SUBJECT: CENTERPOINT PLAZA #SPD-99.43

BRIEF: This is the second public hearing for Centerpoint Plaza for a Final PAD for Z Tejas Grill at 20 W. 6th St.

RE: **DRB99061 - ELLINGSON WAREHOUSE @ CENTERPOINT**

Proposed Conceptual Exterior Elevations

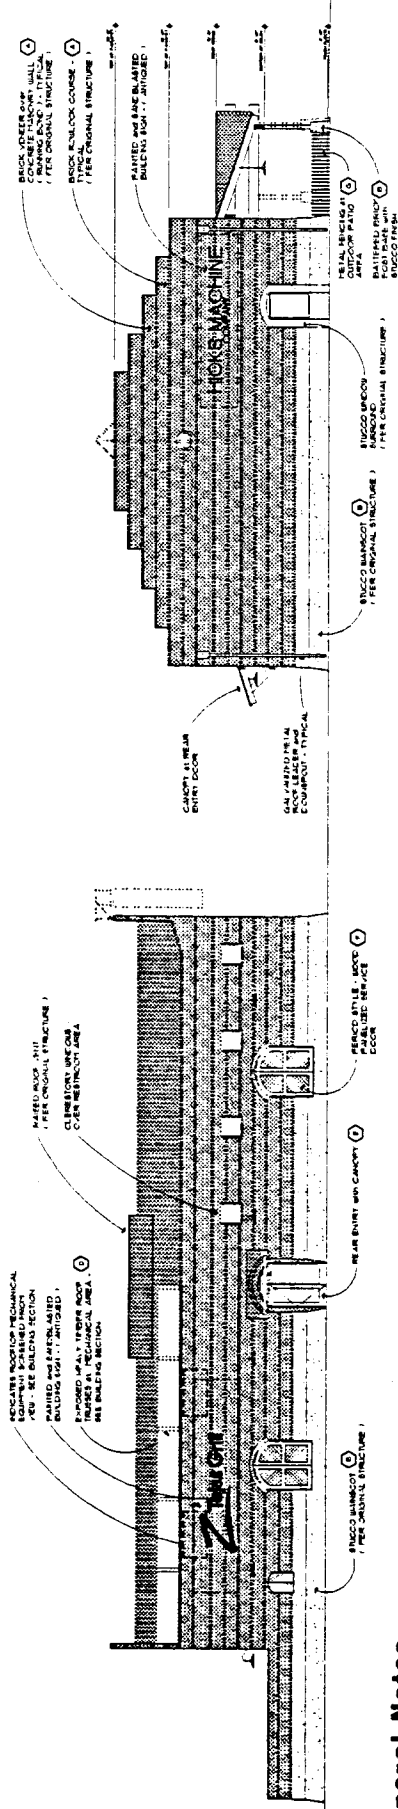
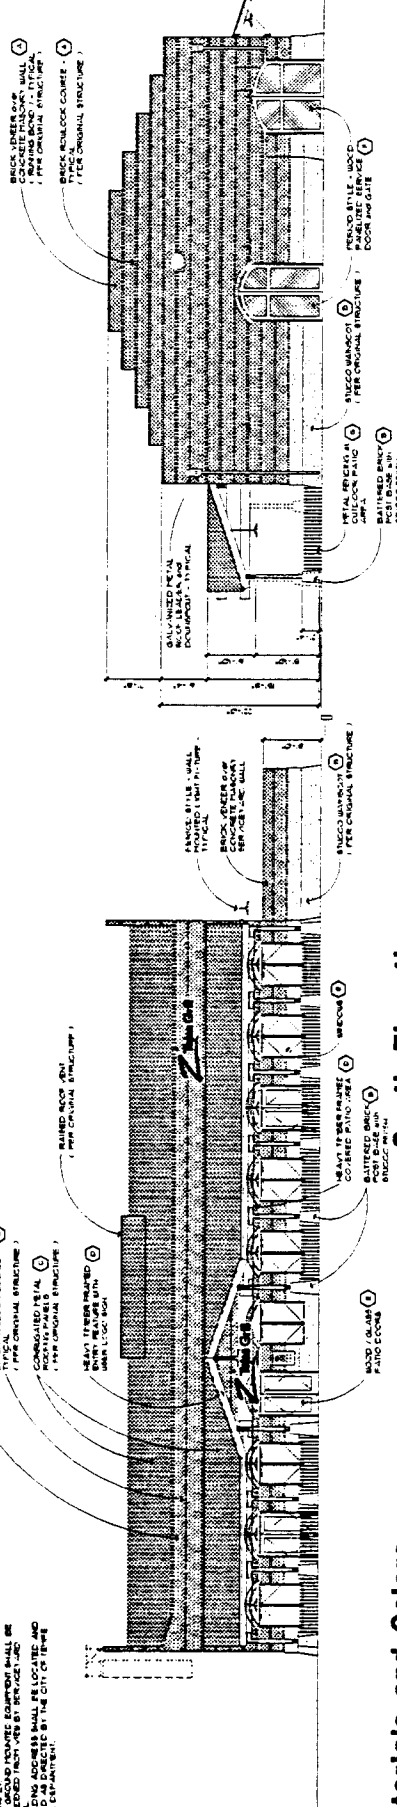
10. Meet with the Planning and CPTED staff to discuss the addition of windows on the north and west elevations.
11. Locate roof access ladder inside the building.
12. The main building colors and materials shall have a light reflectance value (LRV) of 75% or less. Specific colors and materials to be approved by staff prior to issuance of building permits. Final colors shall be field verified by the Design Review staff prior to painting the building.
13. Details of meter panels and electrical equipment installation and location shall not detract from the architecture of the building and shall be approved by staff prior to issuance of building permits.
14. Locate the electrical service entrance section (S.E.S.) inside the building.
